# **Generic Design Assessment of the BWRX-300 – Step 2 Assessment of Internal Hazards**

**Project Name:** Generic Design Assessment of the BWRX-300 – Step 2

**Assessment report reference:** AR-01354

**Document ID:** ONRW-2126615823-8059

**Figure 1 - Overview of the BWRX-300 Internal Hazards Safety Case**

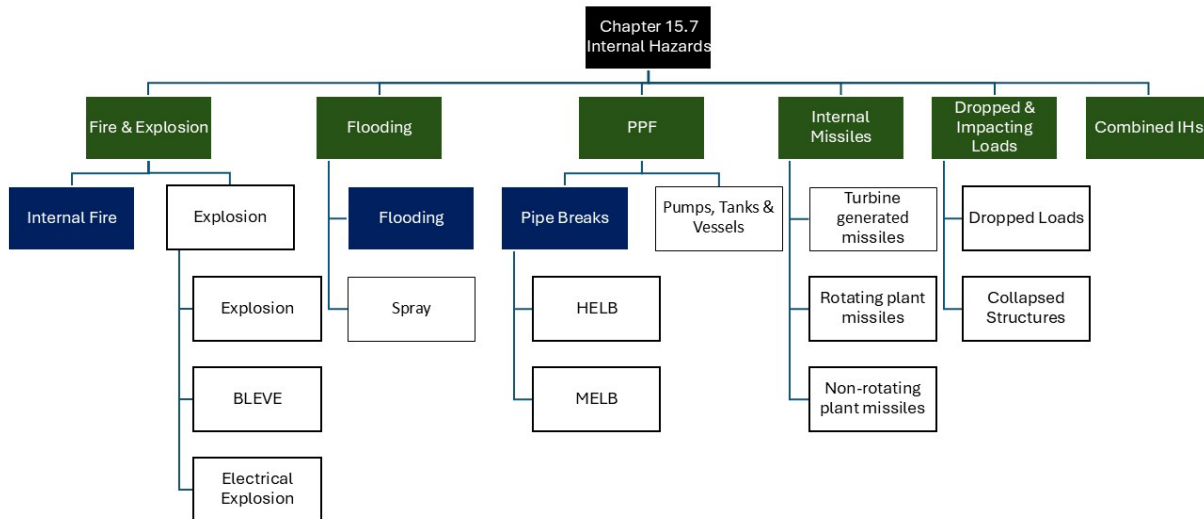
56. The internal hazards aspects covered by the BWRX-300 safety case included internal fire and explosion, internal flooding, internal missiles, pressure part failure (PPF)-related hazards (e.g. pipe whip, jet impact) dropped and impacting loads; and combined hazards. The RP's consideration of internal fire, flooding and pipe break-related hazards were at the highest level of maturity at this GDA Step. Consideration of other hazards was conceptual or not presented at Step 2. Figure 1 above illustrates the structure of the case, with the colour coding representing the differing levels of maturity discussed above.<sup>2</sup>

<sup>2</sup> Figure 1 colour coding: (green) hazards presented at GDA Step 2; (blue) highest level of maturity at GDA Step 2; (unshaded) hazards at a conceptual level or not presented at Step 2. An outline of the combination hazard methodology was presented at Step 2 with sub-topics to be considered as part of future development of the safety case.
